County File: OAR2536

City of Fountain Project: FP-25-005

Re: 6580 Southmoor Dr – Kota Ray Subdivision

Final Plat_V1

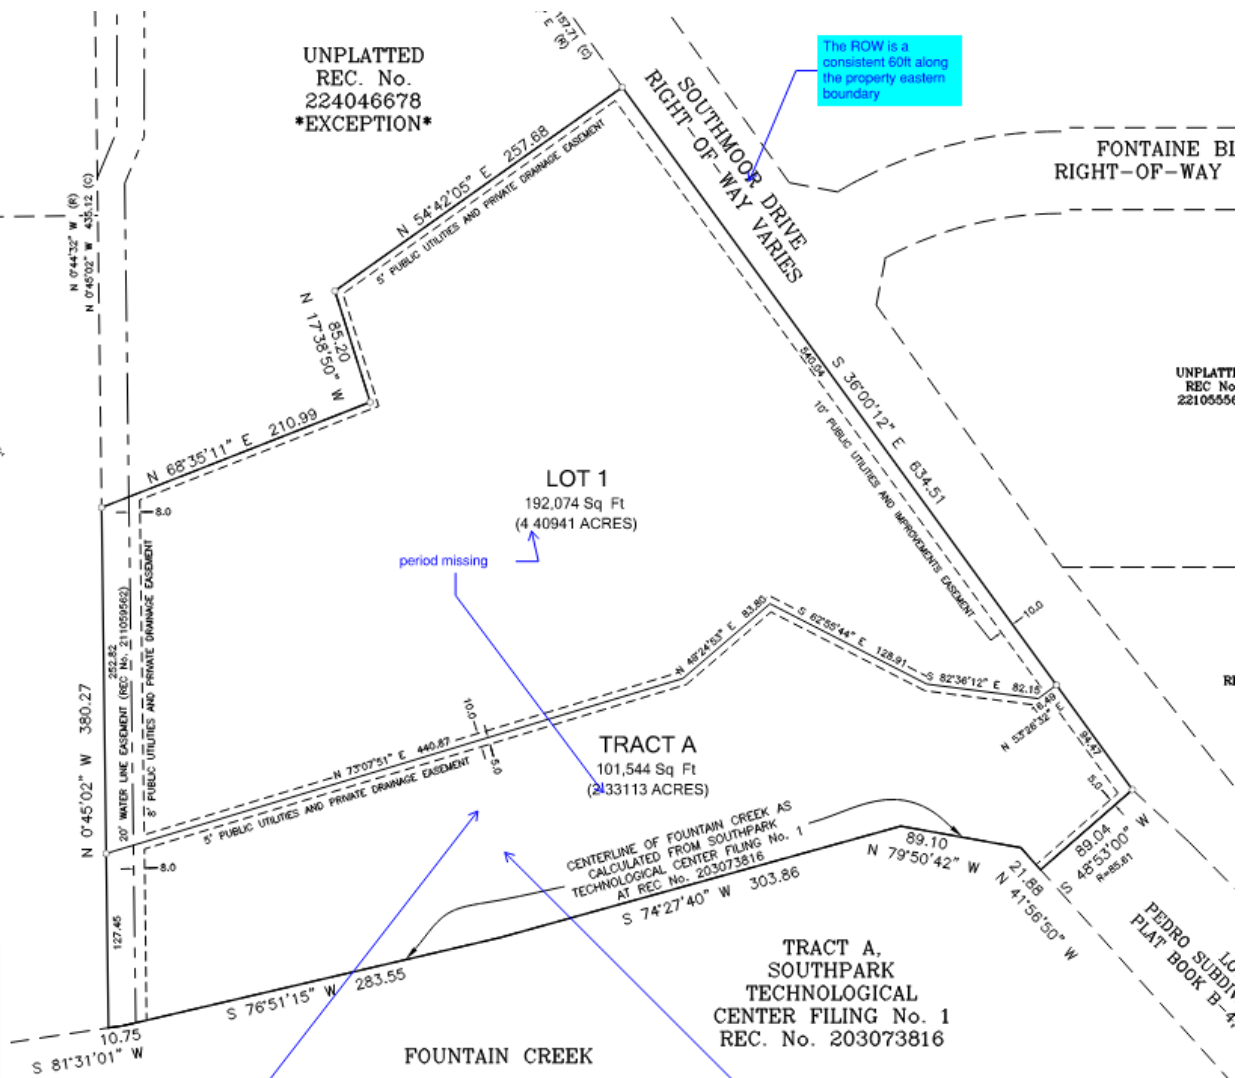
A restrictive flood zone note should be added

Who is responsible for creek channel and bank maintenance. Property owner or City of Fountain? Should be spelled out explicitly. A channel maintenance agreement should be completed.

The ROW is a consistent 50ft along the property eastern boundary

add adjacent parcel # 6524200026
UNPLATTED BOOK 2227, PAGE 69
